AUTOMATIC TRANSMISSION SERVICE GROUP

REVISED EDITION

Since the introduction of the THM 440-T4 Transaxle in April, 1984, there have been many major engineering design changes. These changes have affected nearly every part used in the THM 440-T4. This Update Handbook will explain each change, the parts affected by the change, and any parts interchangeability problems created by the change.

Figure 70

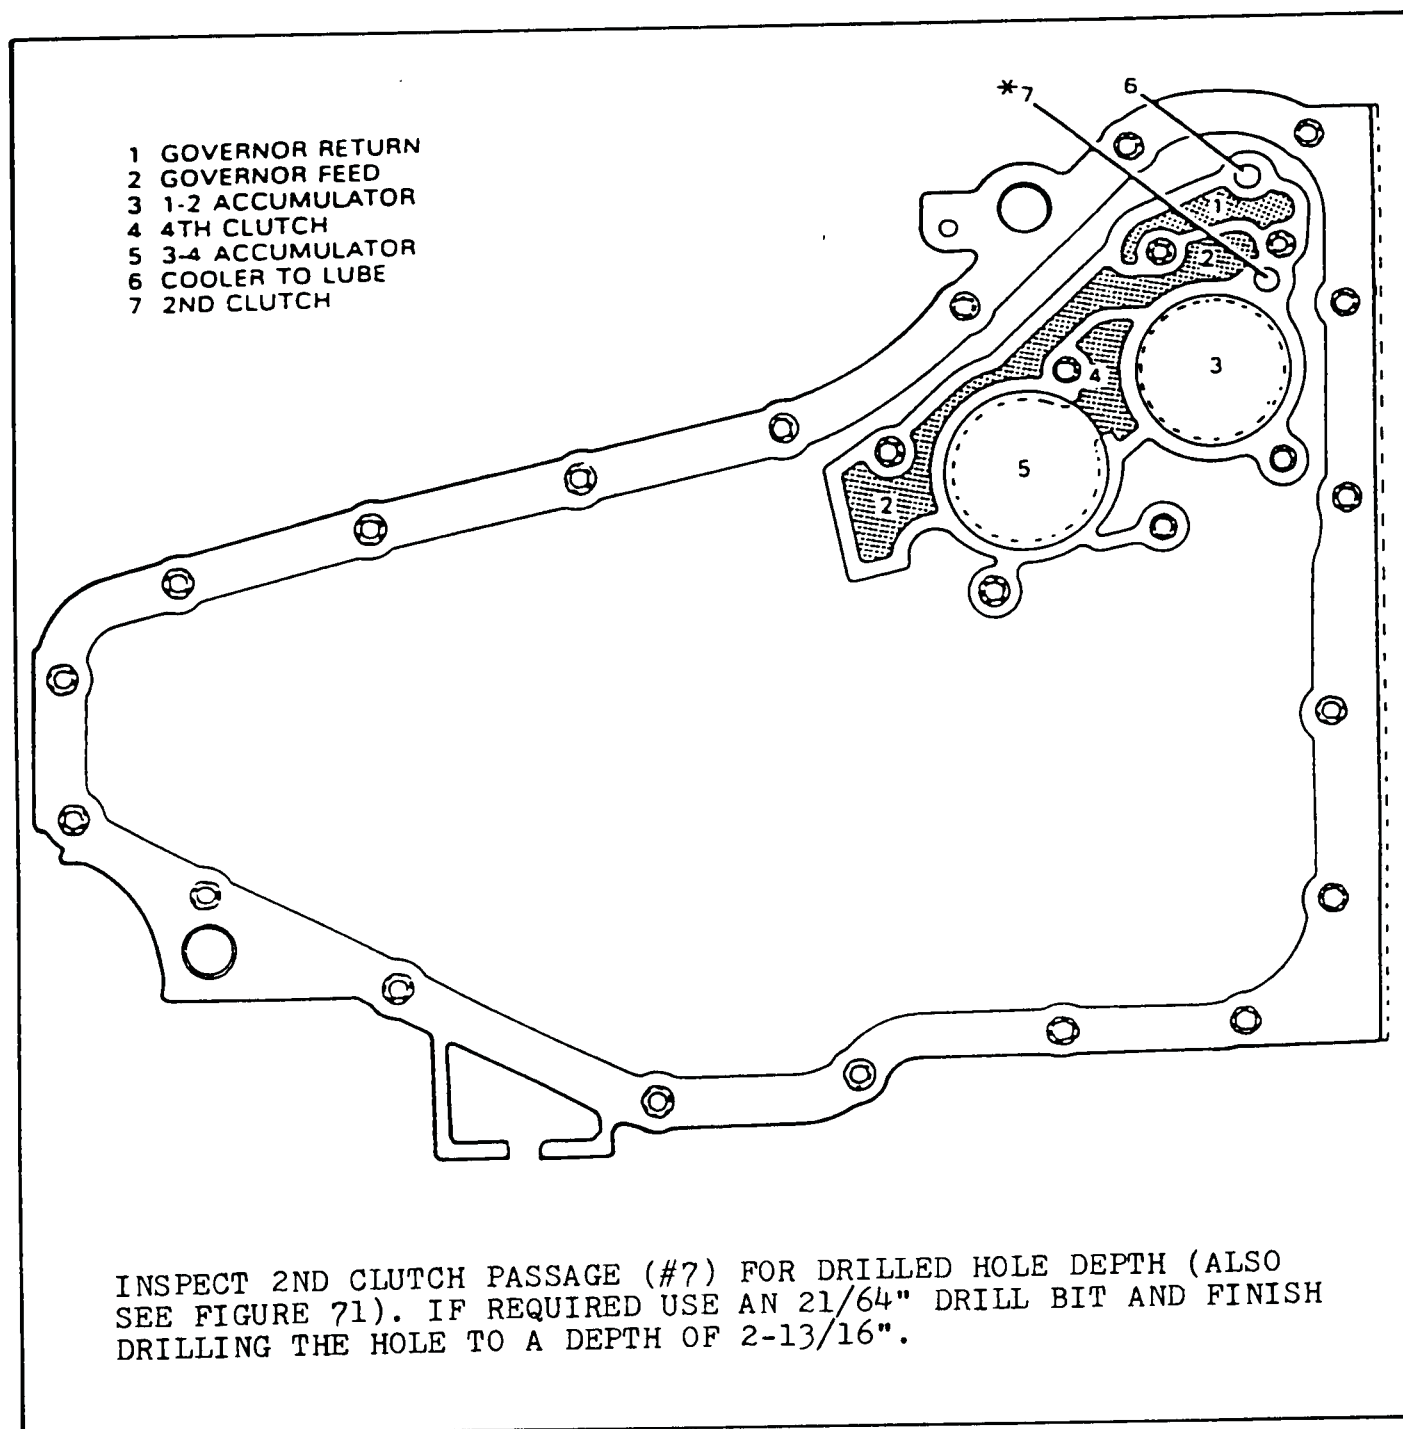
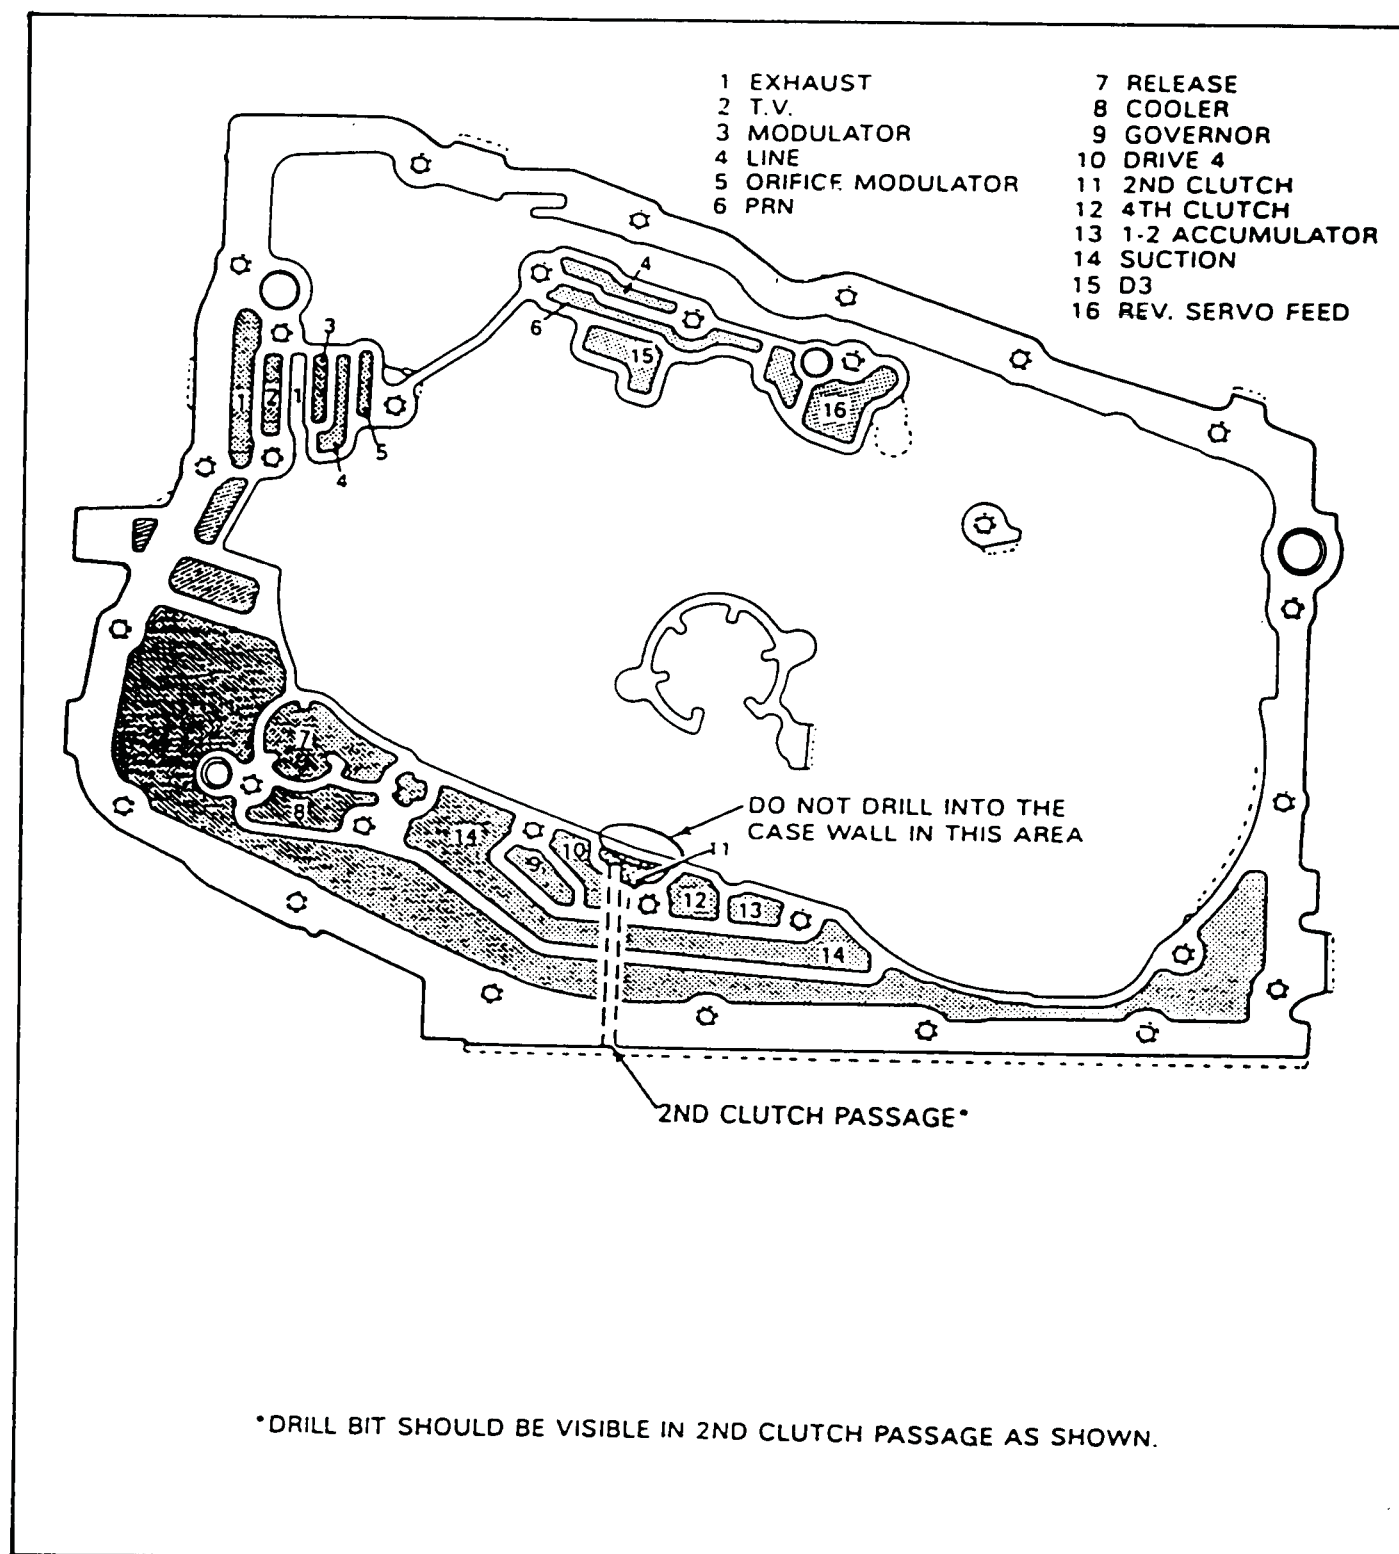
- COMPLAINT: Consistently harsh 1-2 shift condition at any throttle angle and any altitude.
- CAUSE: This harsh shift condition may be caused by a blocked, or partially drilled 2nd clutch feed passage in the case.
- CORRECTION: To repair this condition inspect the 2nd feed passage, #7 in Figure 70, for blockage or incomplete drilling operation. To perform this inspection, remove the trans-axle oil pan, filter, accumulator cover (With feed pipes and retainer), accumulator cover spacer plate and gaskets. Inspect the 2nd clutch passage by measuring the depth of the hole, which should be a minimum of 2-13/16" as shown in Figures 70 and 71.

1. Remove the transaxle from the vehicle and disassemble components up to and including the channel plate.
2. Mark a 21/64" drill bit at 2-13/16" from the end using a drill stop or tape. From the oil pan side of the case, finish drilling the 2nd clutch passage to the proper depth as marked on the drill bit.

3. Remove metal chips caused by drilling and thoroughly flush the repaired case passages with clean solvent.
4. Reassemble the transaxle.

Figure 73

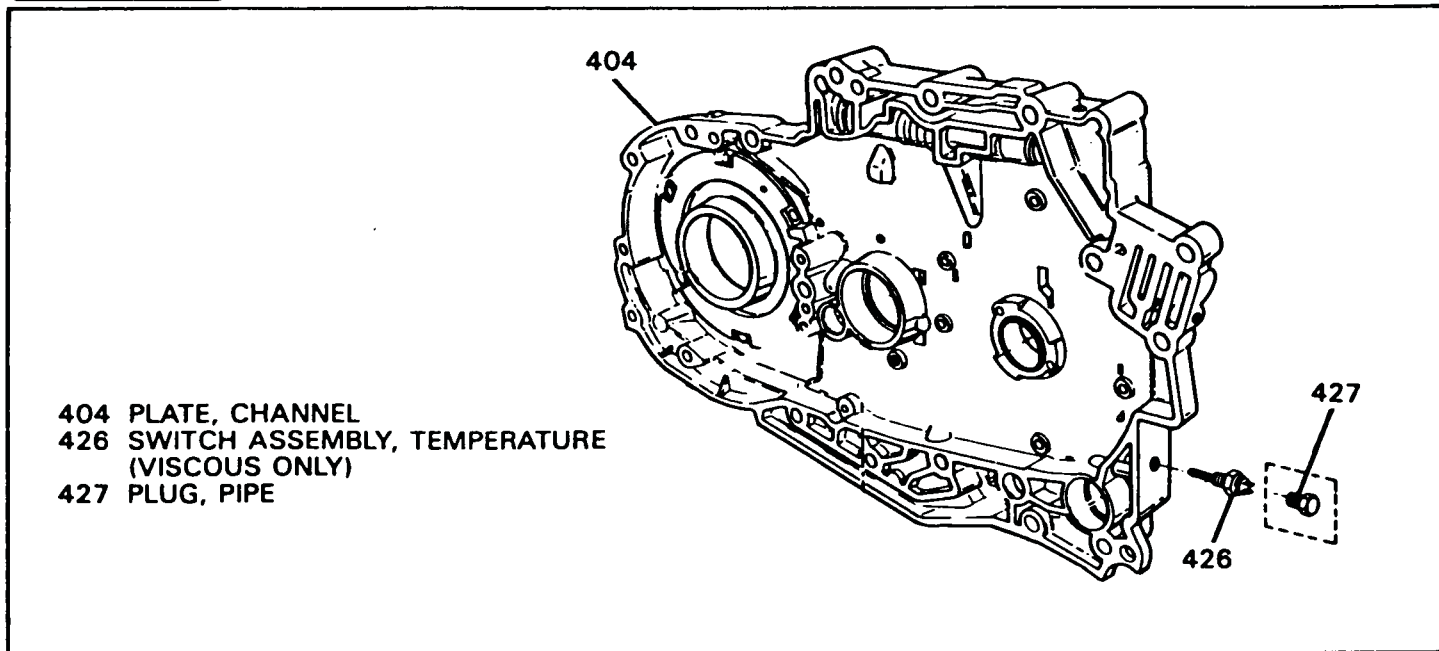
CHANGE: Thermister located in oil pump housing moved into cooler line (See Figures 72 & 74). Temperature switch in channel plate was also eliminated (See Figure 73).

- (1) Thermister - Removed from pump housing (See Figure 72).
- (2) Temperature Switch - Eliminated (See Figure 73).
- (3) Cooler Line - Temperature Sensor added (See Figure 74).
- (4) Case Connector - "E" terminal that normally carried the thermister wire is now empty (See Figure 75).
- (5) Vehicle Wiring Harness.

Figure 76

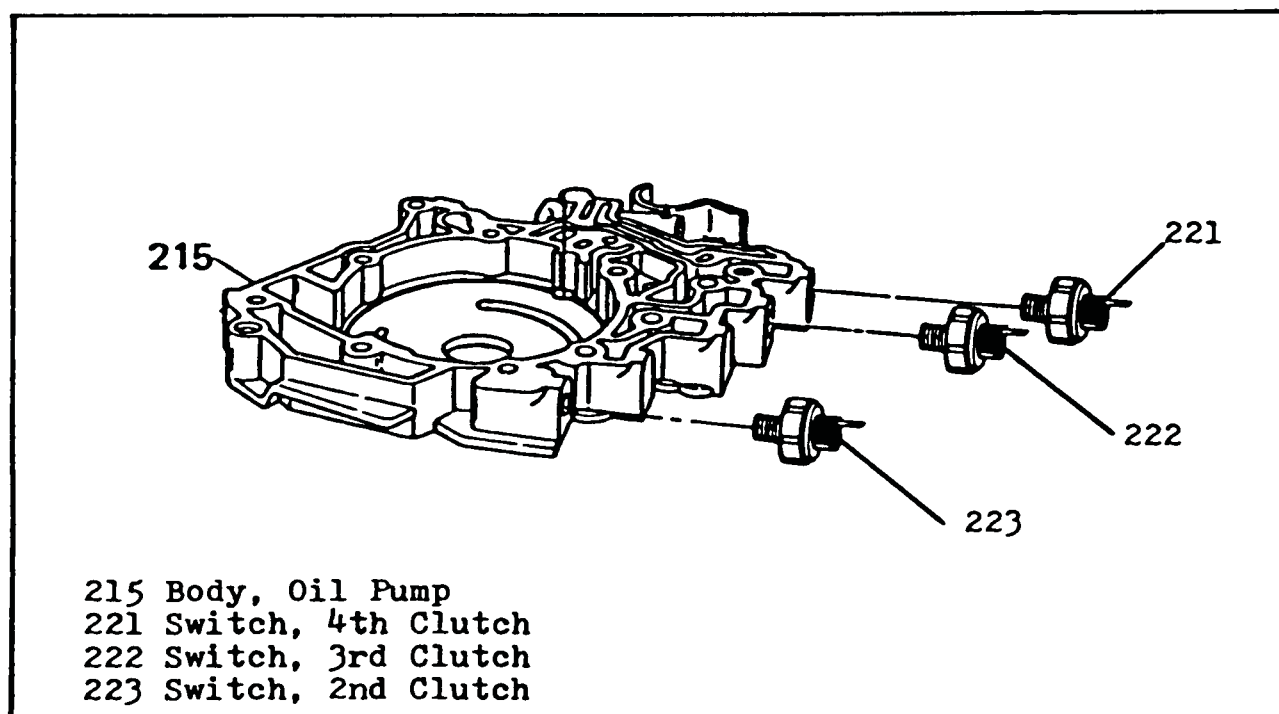
CHANGE: 2nd clutch switch added on pump housing (Some Models).

- (1) Pump Body - Drilled and tapped for 2nd clutch switch.
(See Figure 76).
- (2) Valve Body - Extra hole drilled in valve body to carry 2nd clutch oil to pump body.
- (3) Case Connector - Now round black connector (Same as Cadillac), and "E" terminal now carries 2nd clutch signal wire (See Figure 77).
- (4) Transaxle Wiring Harness - Extra wire in harness for 2nd clutch signal to ECM (See Figure 77).
- (5) Vehicle Wiring Harness

Figure 80

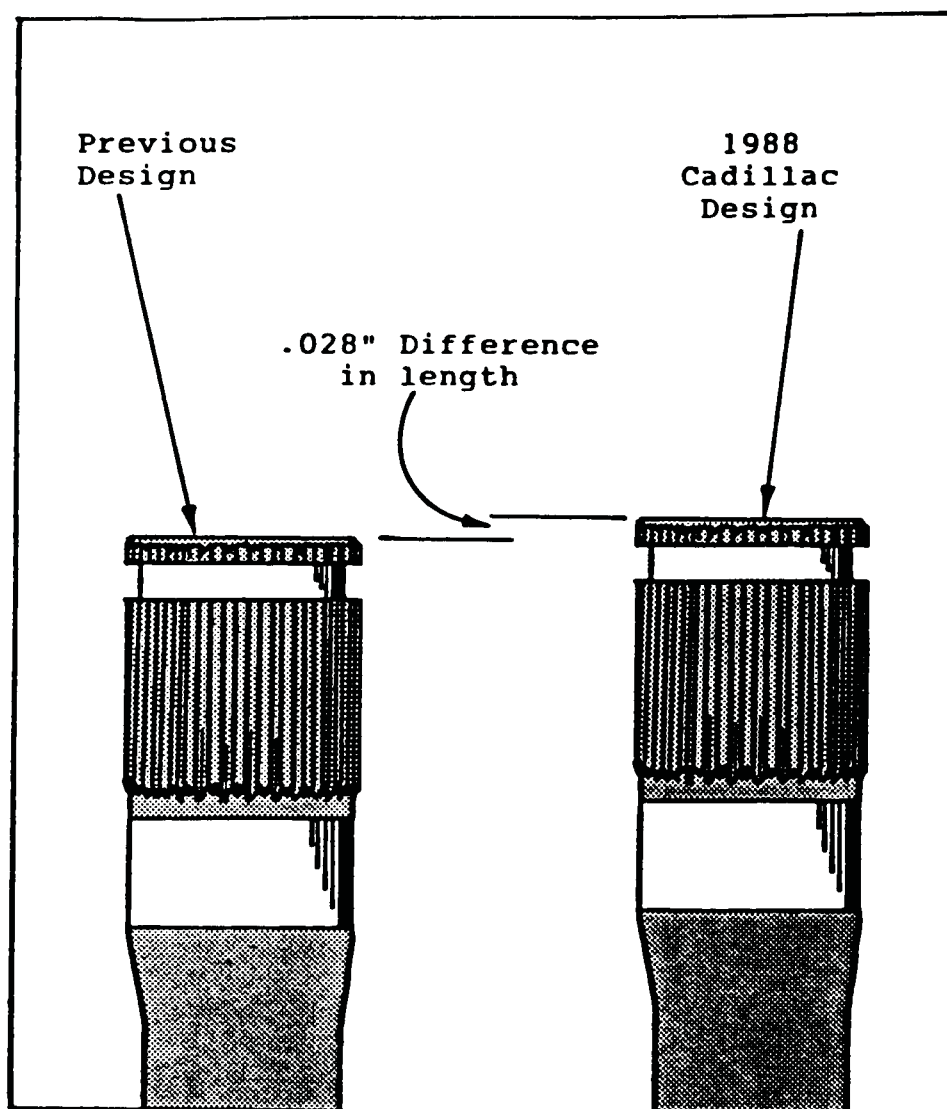
- (1) Differential Side Gears - Revised dimension (Thicker), and they have 16 teeth instead of previous 15.
- (2) Differential Pinion Gears - Revised dimension, and have 10 teeth instead of previous 11.
- (3) Side Gear Thrust Washers - Revised dimension.
- (4) Pinion Gear Thrust Washers - Revised dimension.
- (5) Differential Housing - Revised dimensions (Internal), to accept new side gears and new pinion gears.
- (6) Differential Pinion Shaft - Black in color to identify the new design final drive assembly (See Figure 79). Also is a smaller diameter.
- (7) Output Shaft - Longer (.028"), so that it will extend through the thicker side gears, to get "C" clip installed. The longer output shaft can be identified by green paint on the end of the shaft opposite the "C" clip end (See Figure 80).

Figure 81

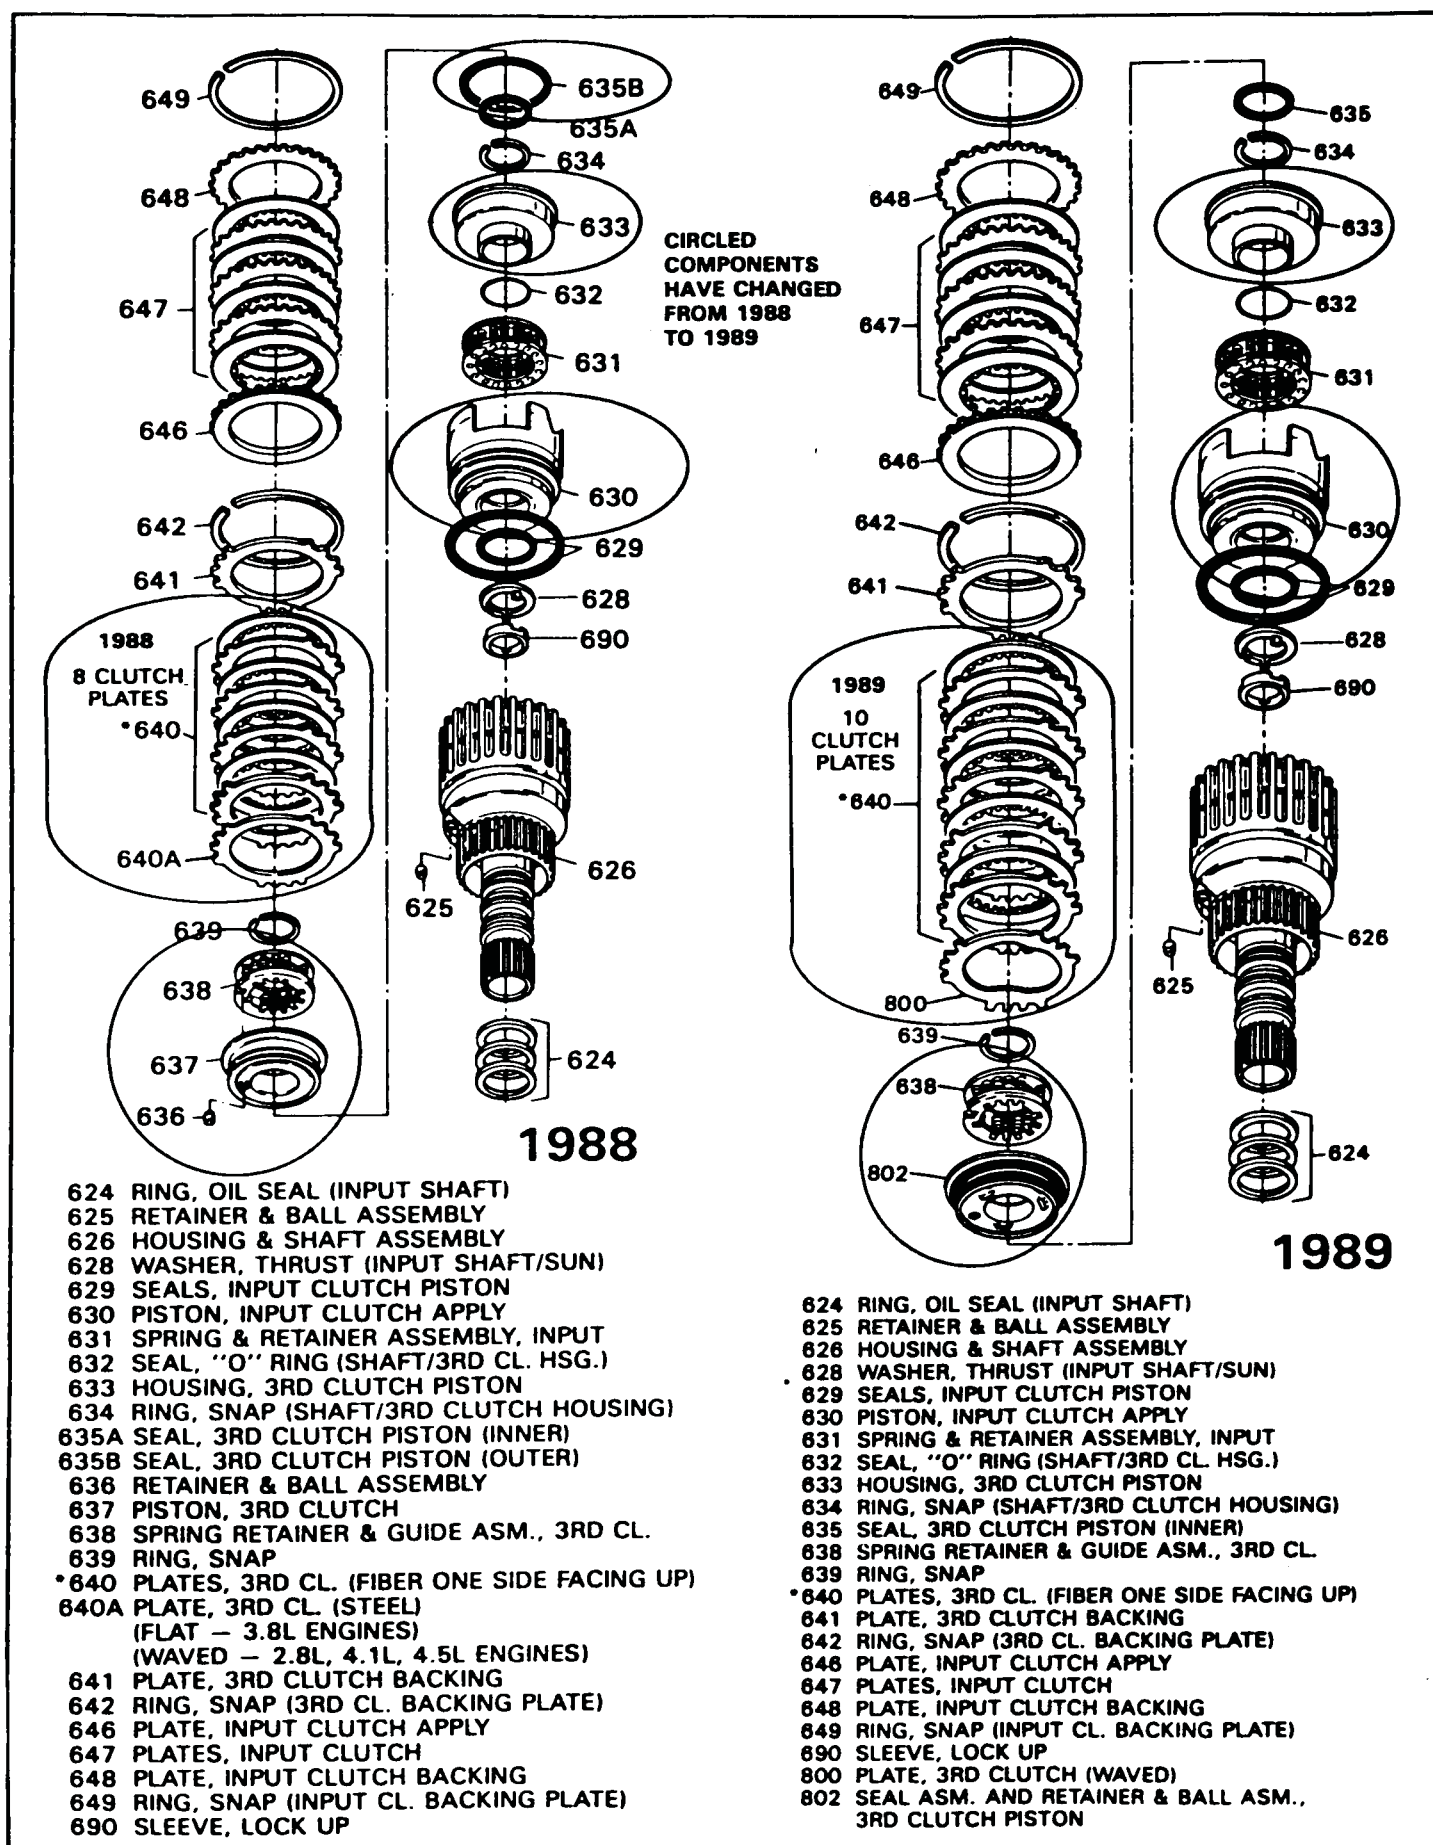
CHANGE: The single sided 3rd clutch plates were "Increased" from the 8 plate clutch pack to a 10 plate clutch pack for all 1989 model THM 440-T4 transaxles (See Figure 81).

REASON: The two extra plates were added for greater clutch capacity, because of the new higher torque engine applications.
"SEE SPECIAL NOTE"
